RAPID CITY REGIONAL AIRPORT**ADDENDUM NO. 3**

**Request for Proposals – Integrated Terminal Technology Package
Comprising CUPPS, CUSS, MUFIDS (Including GIDS and BIDS), and Digital Backwall Video Signage
Rapid City Regional Airport**

Date of Issuance: August 12, 2026

**RAPID CITY REGIONAL AIRPORT
RENOVATION AND EXPANSION PROJECT
PROJECT 1 PHASE 3**
Rapid City, South Dakota

T-101A

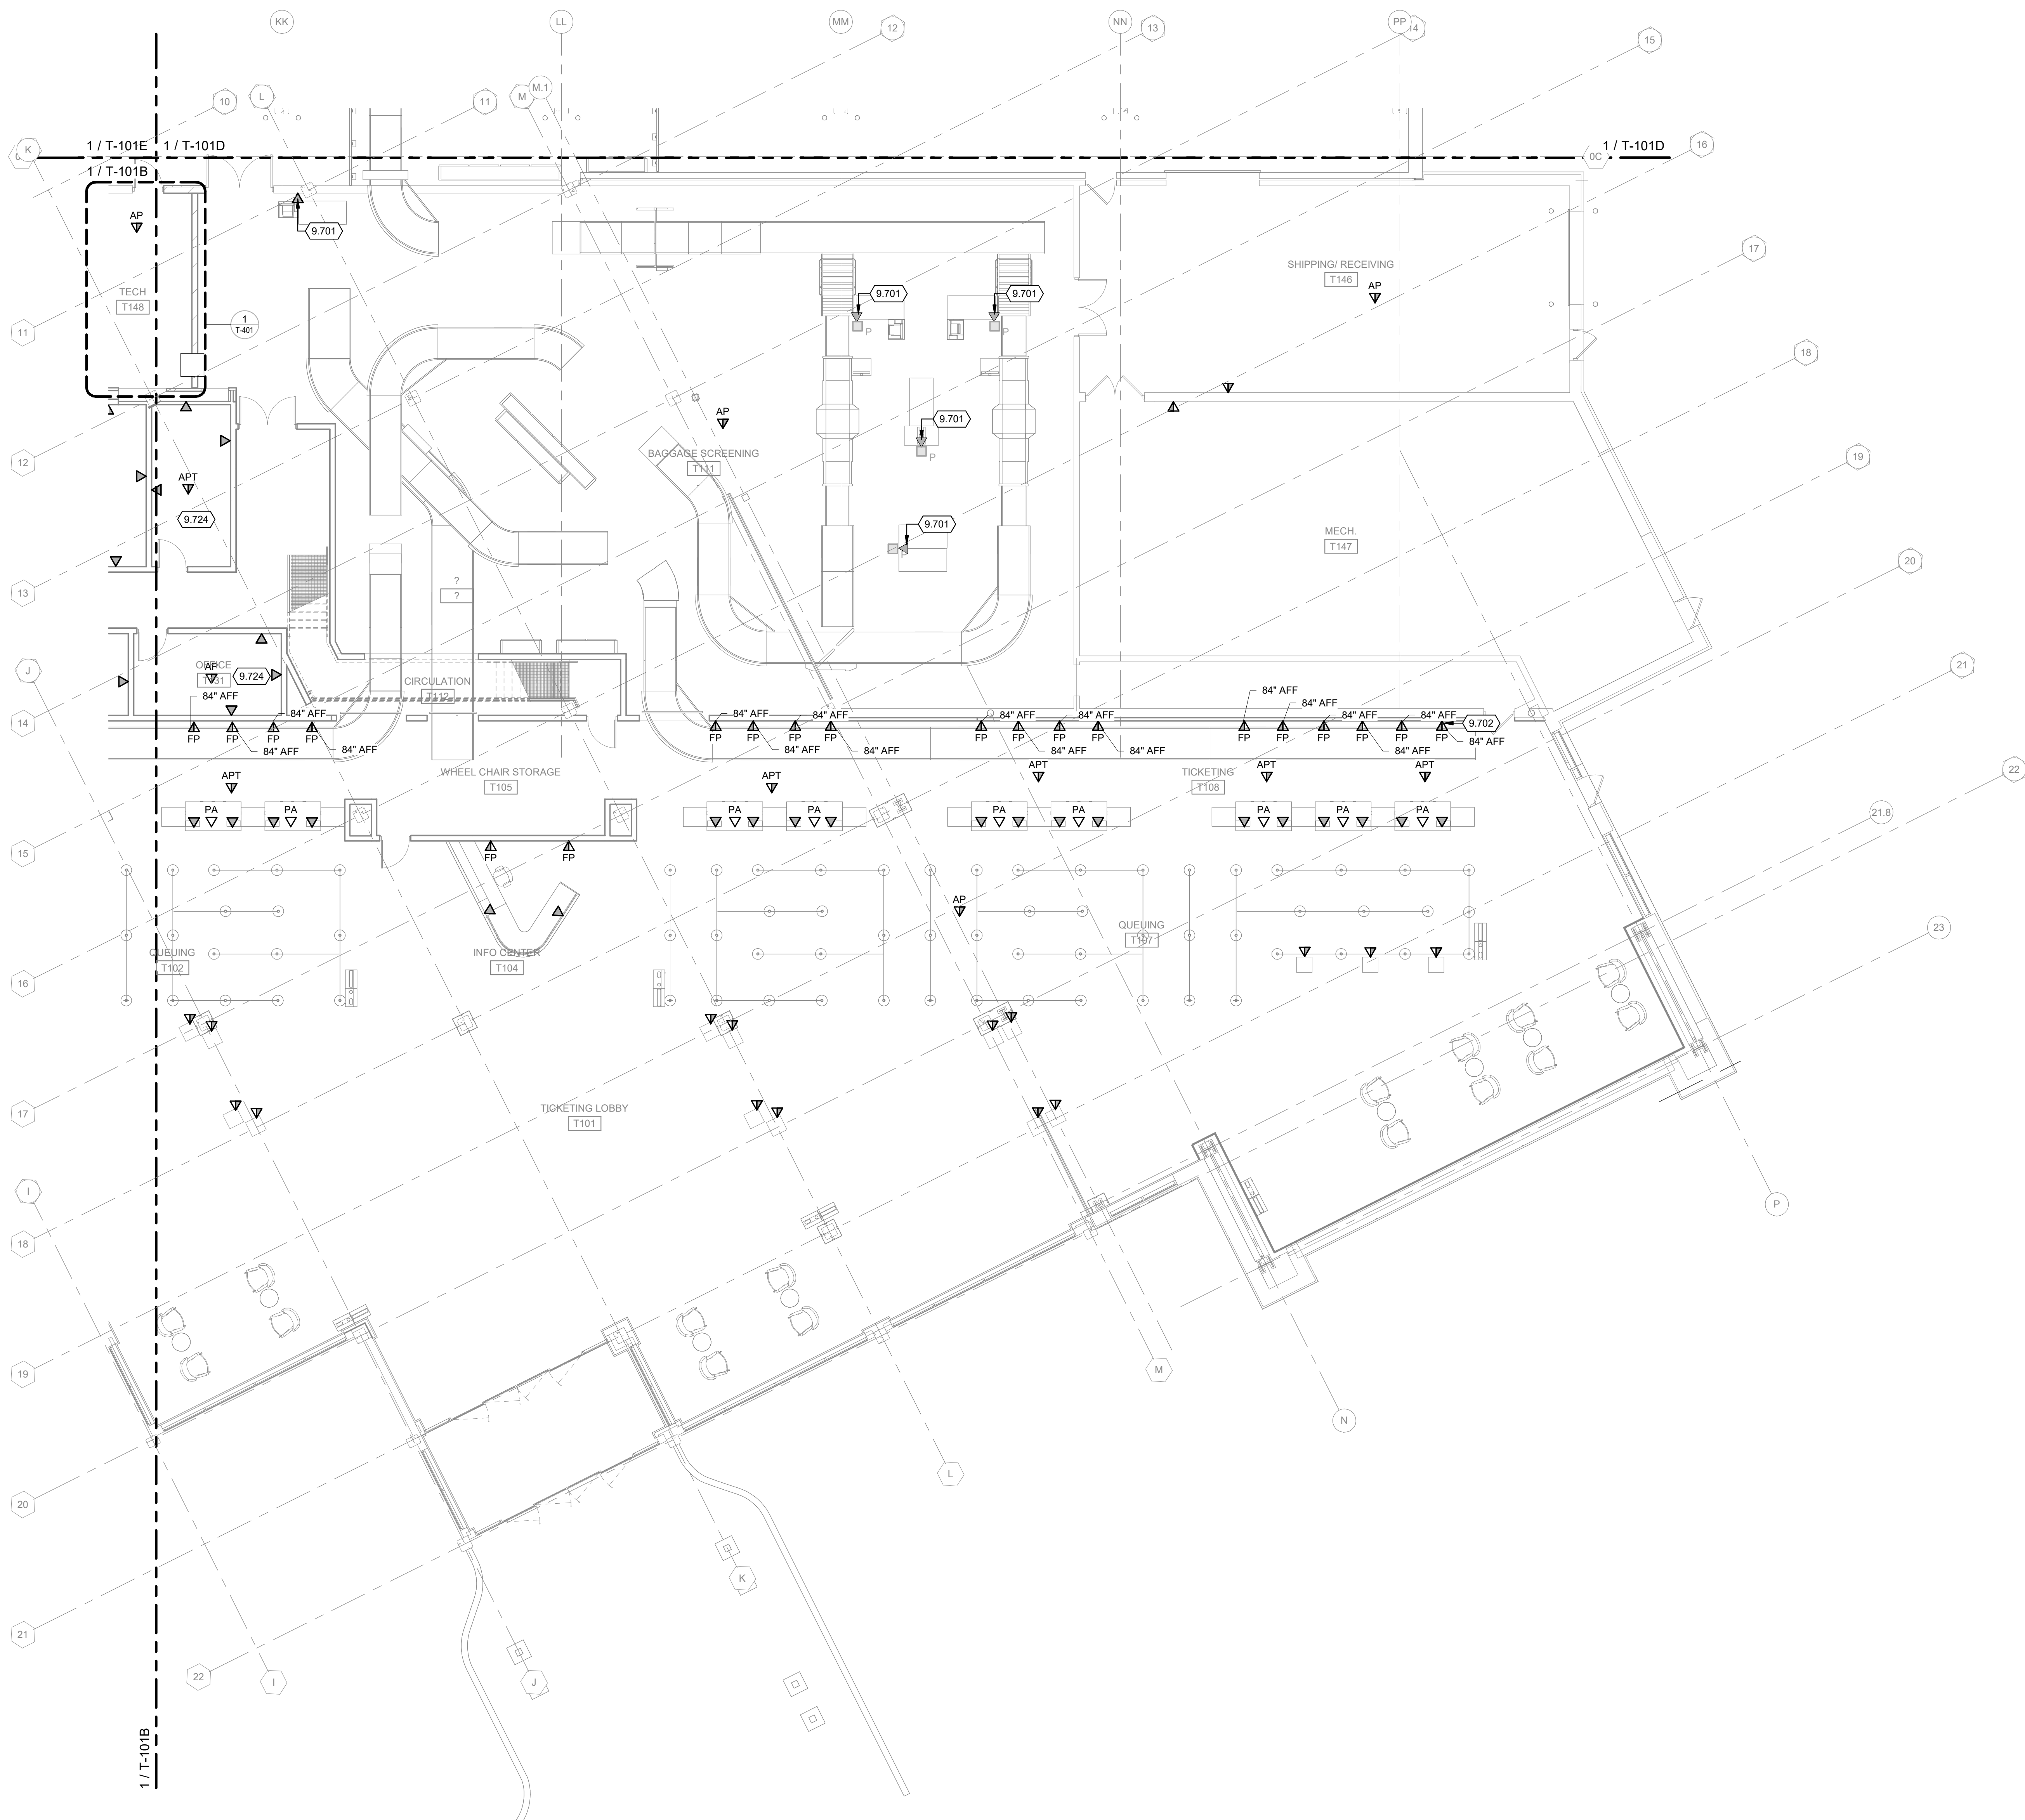
As Attachment 8 to this Addendum, the Airport is issuing Sheets T-101A, T-101B, and T-101D (First Floor Communications Plans, Areas A, B, and D – Phase 3) for Proposers' general awareness of cable pathway and outlet locations, consistent with Section 3.0 of the Existing System Technical Reference Packet.

Proposers are advised that, per Keyed Note 9.724 on these sheets, technology outlets depicted in airline offices are placeholders for bidding purposes only; final outlet and jack counts will be determined during construction. Proposers shall not size hardware, licensing, or port requirements solely to the outlet counts depicted on Attachment 8.
